UNITED STATES
DEPARTMENT OF THE INTERIOR
BUREAU OF LAND MANAGEMENT

FORM APPROVED
OMB NO. 1004-0135
Expires: July 31, 2010**SUNDRY NOTICES AND REPORTS ON WELLS**
*Do not use this form for proposals to drill or to re-enter an abandoned well. Use form 3160-3 (APD) for such proposals.***SUBMIT IN TRIPLICATE - Other instructions on reverse side.**

OXY USA Inc. - Proposed
LaMunyon Federal #3
API No. 30-025-10815

Permanent Abandonment of Federal Wells
Conditions of Approval (LPC Habitat)

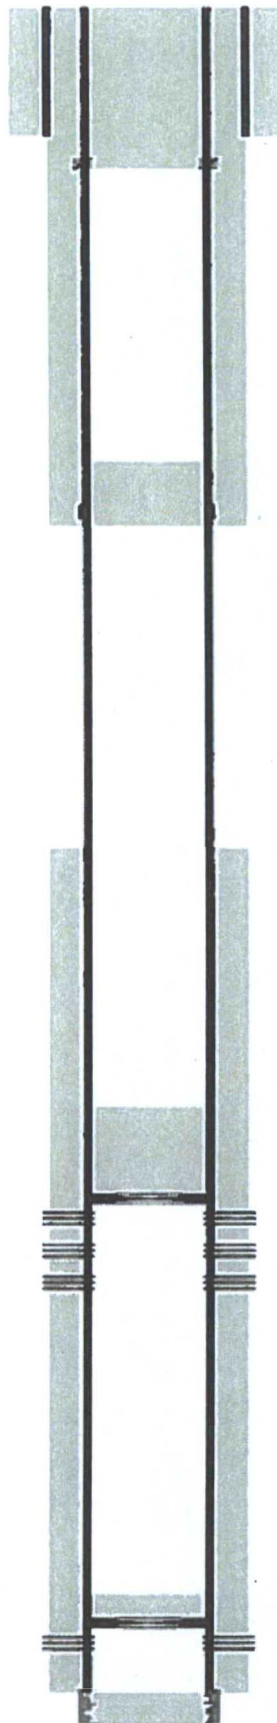
** BLM REVISED ** BLM REVISED ** BLM REVISED ** BLM REVISED ** BLM REVISED **

1170
25sx @ 1130-1015' WOC-Tag

RSLr 1035
TOS 1120
Vates 2540

CIBP @ 2450' w/ 25sx cmt
